CONSTRUCTION PLANS
FOR
VILLAGE AT LORSON RANCH
STREET AND STORM SEWER
CONSTRUCTION PLANS

**VILLAGE AT LORSON RANCH
STREET AND STORM SEWER PLANS
COVER SHEET**

V1_street-storm plans.pdf Markup Summary

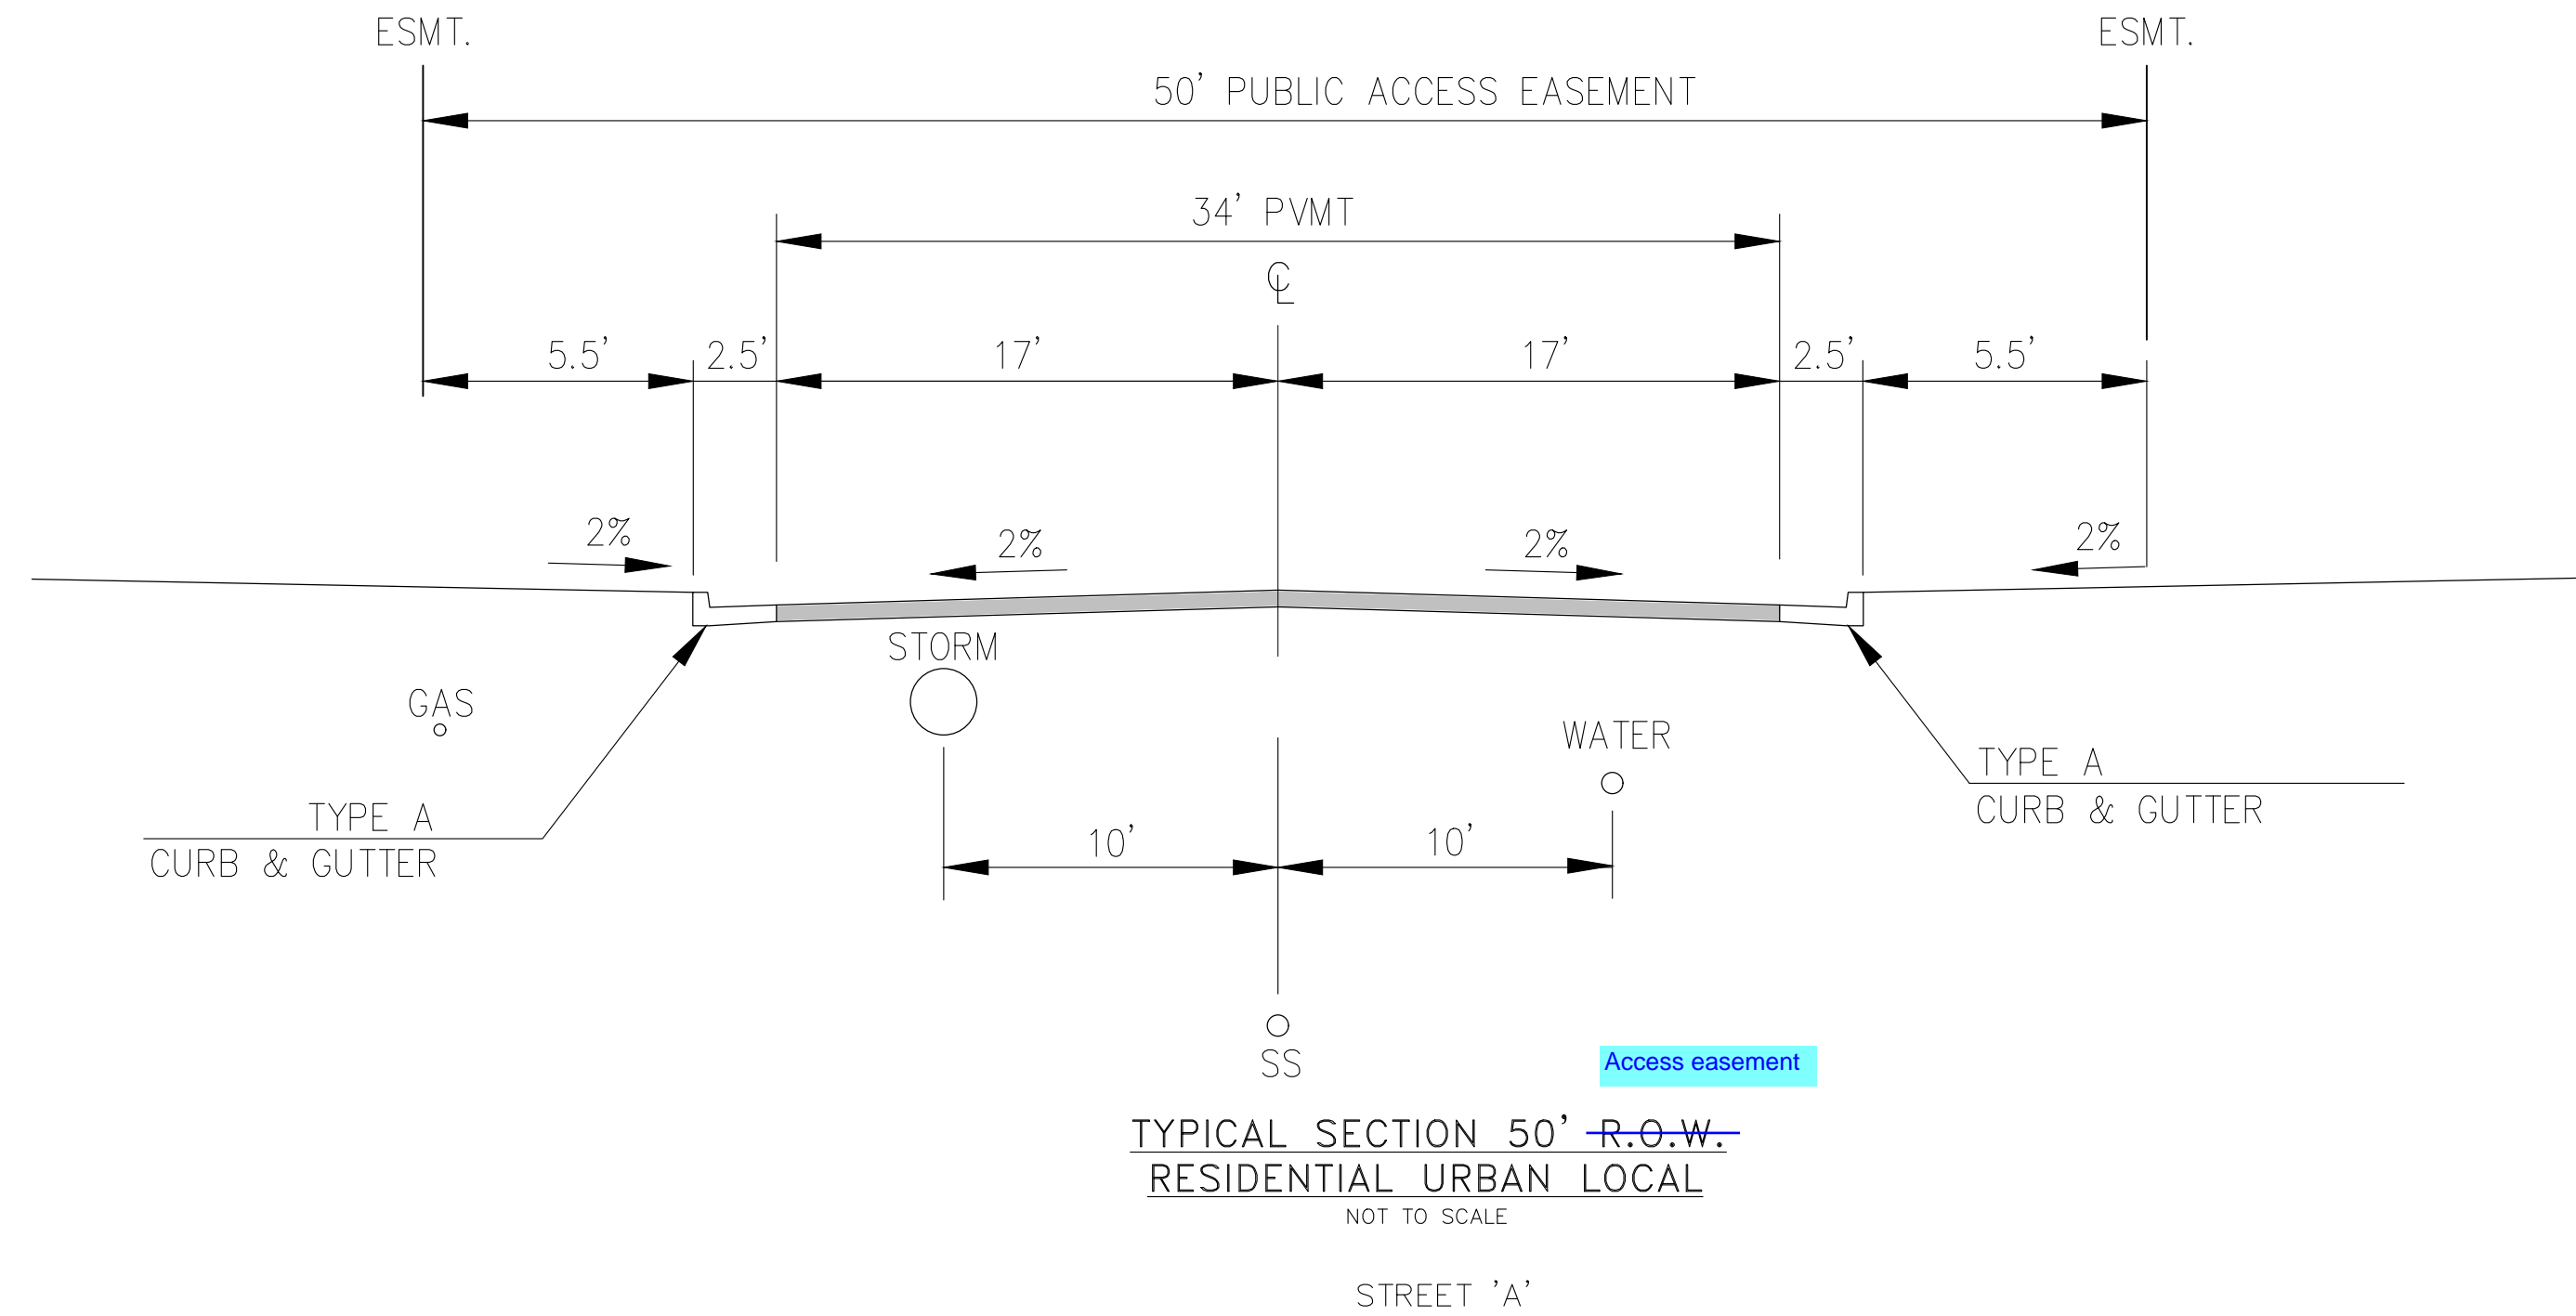
NOTE:
Pavement section to be determined
by Hveem analysis and design. Design
to be approved by El Paso County PCD Engineering

TYPICAL SECTIONS

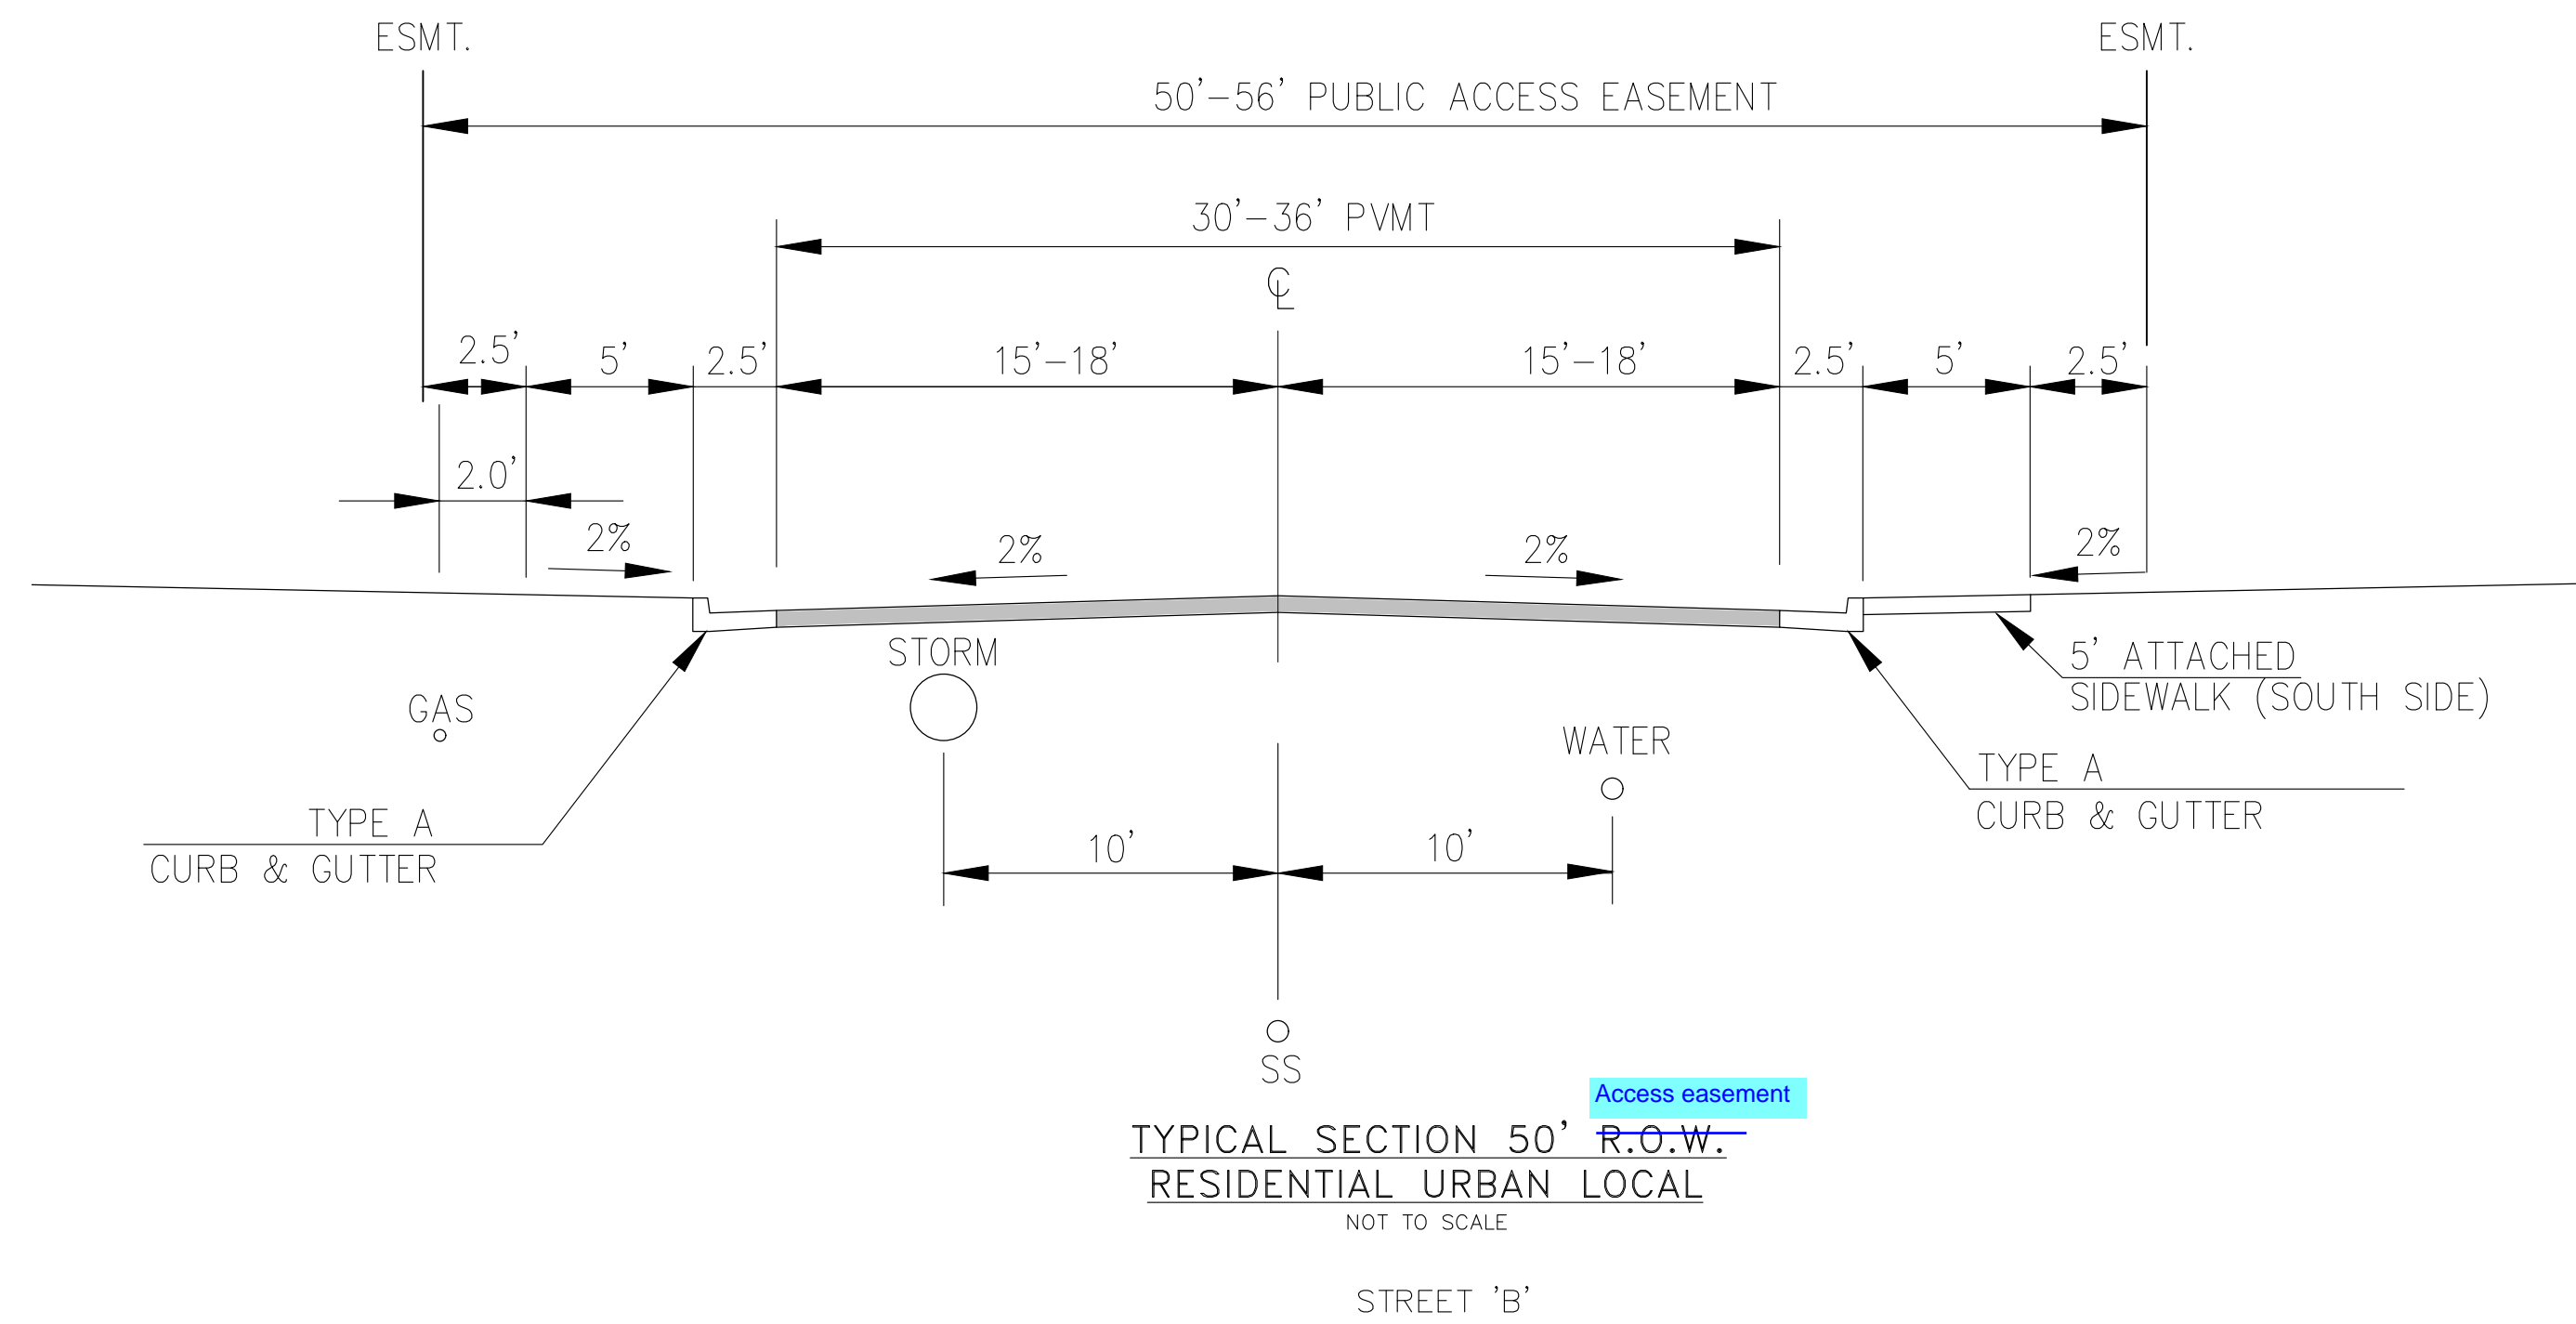
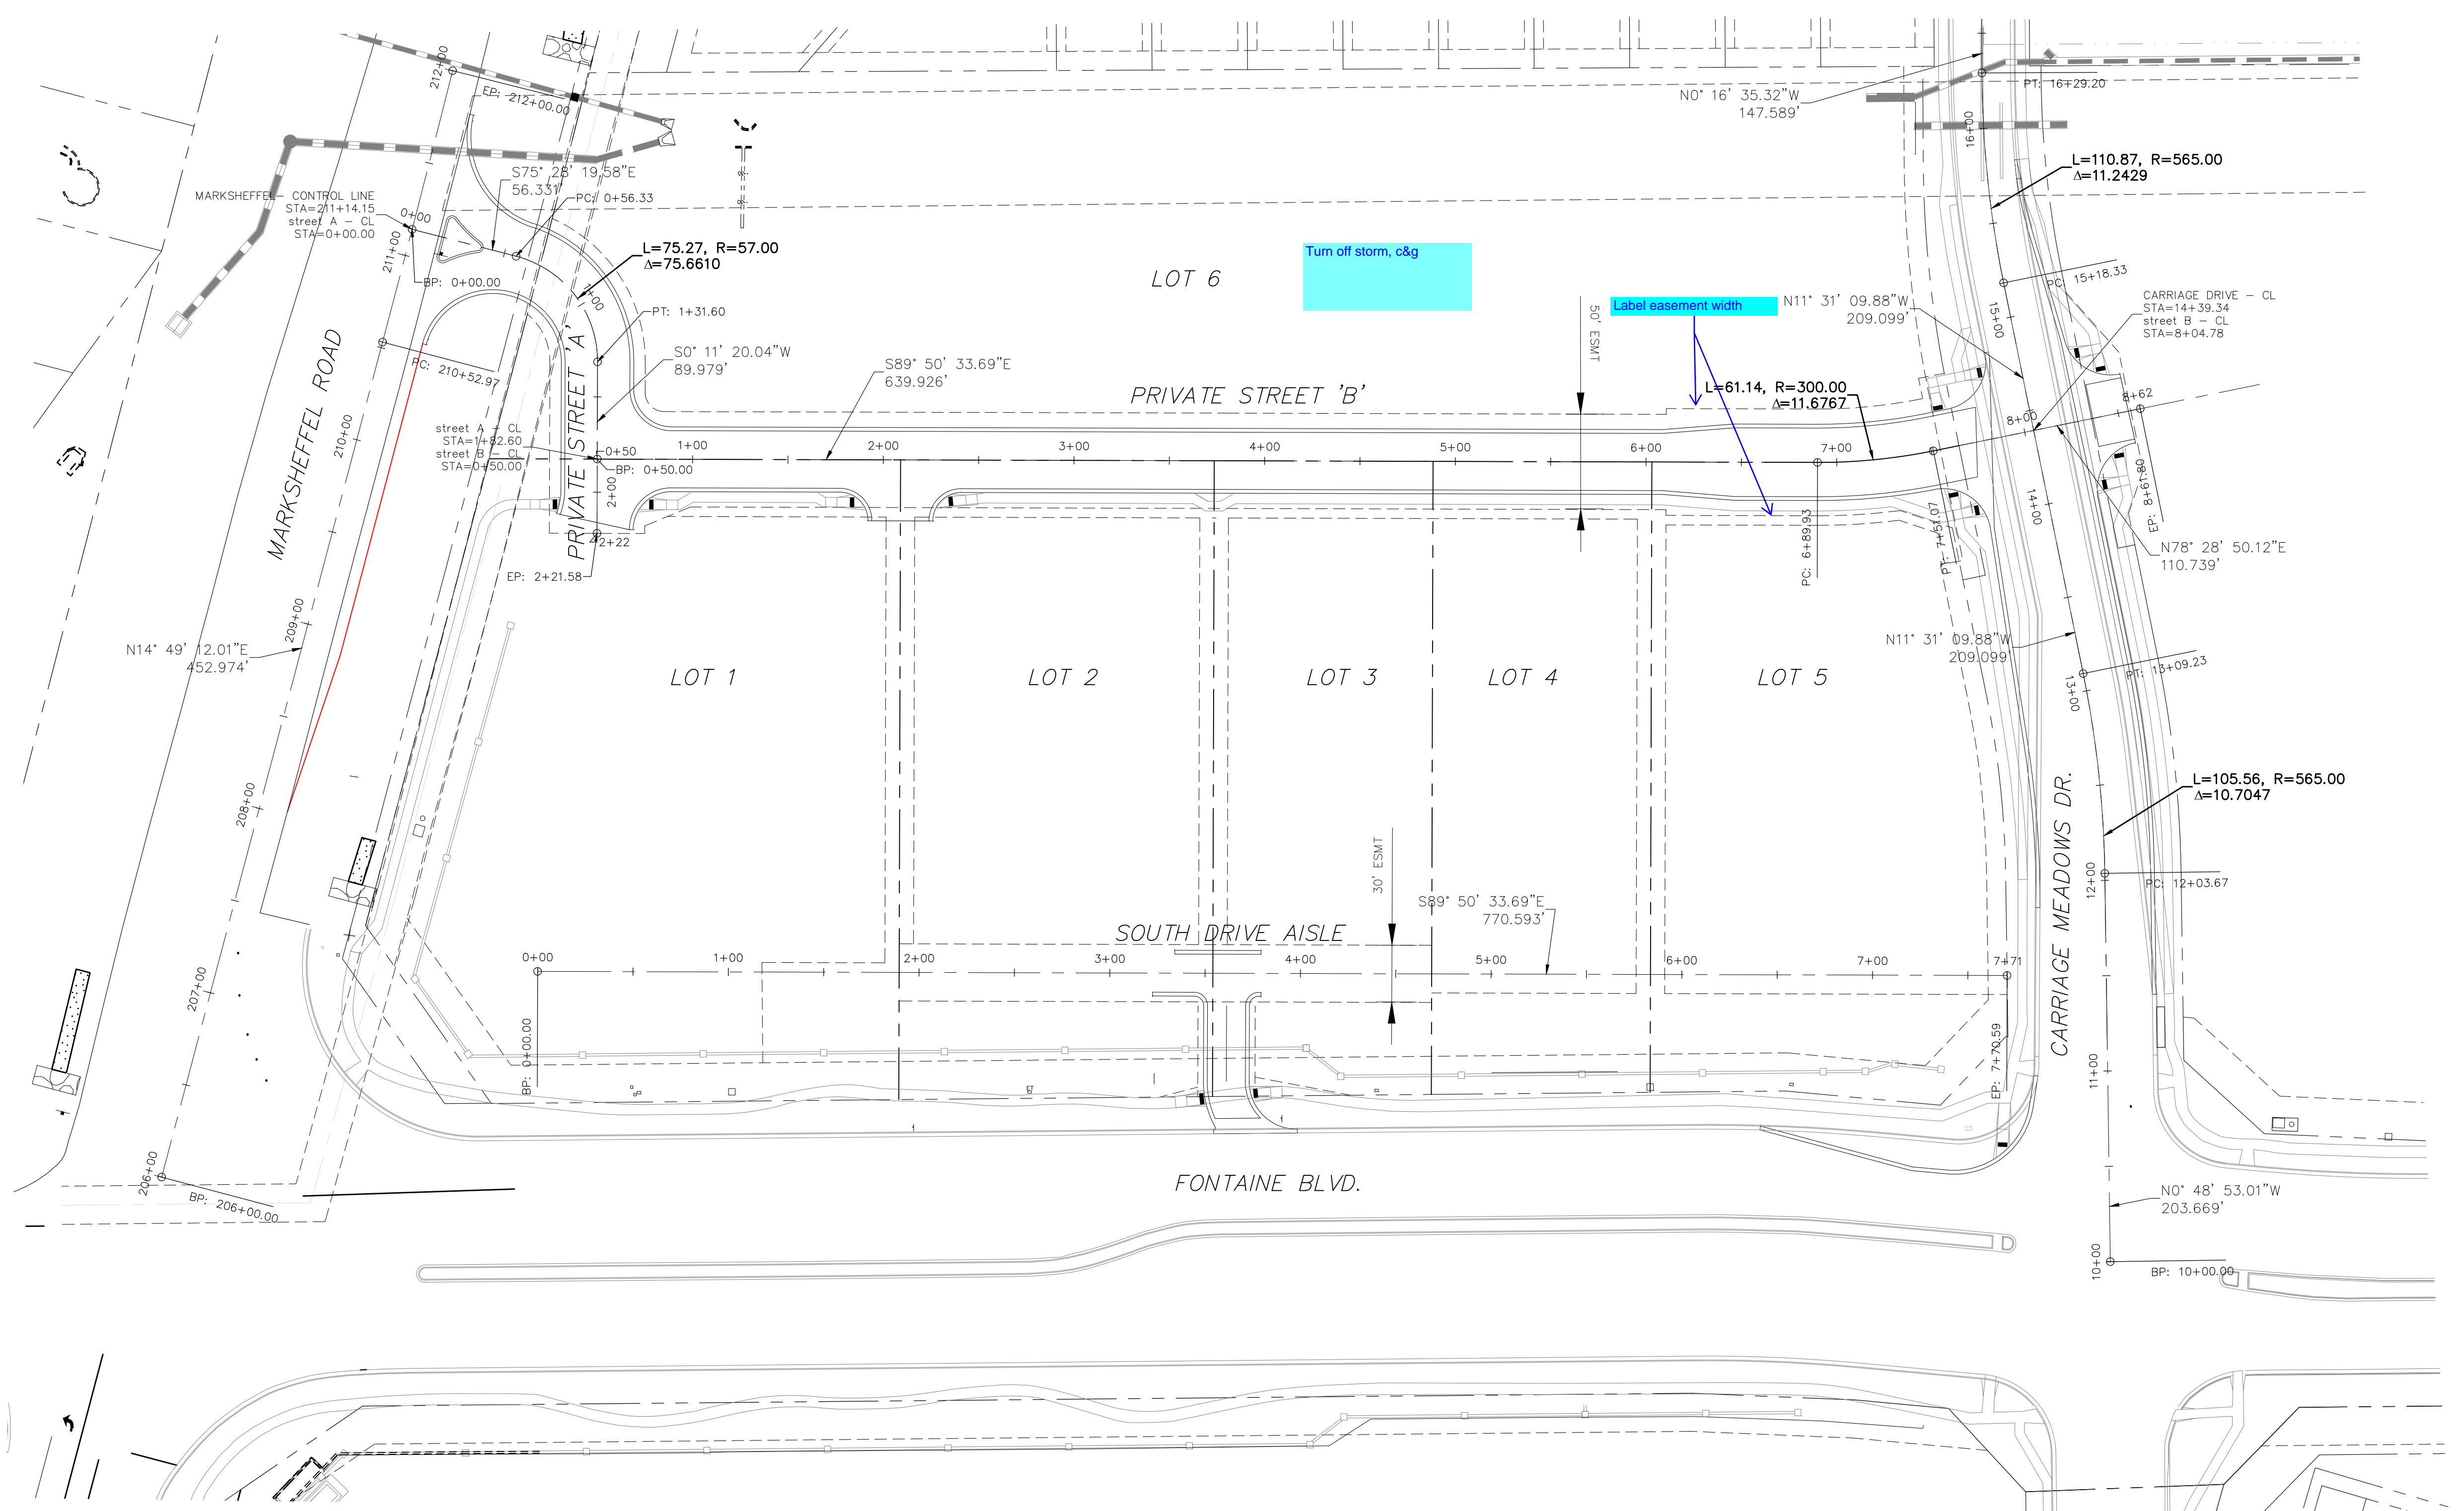
Show typical section for south drive aisle
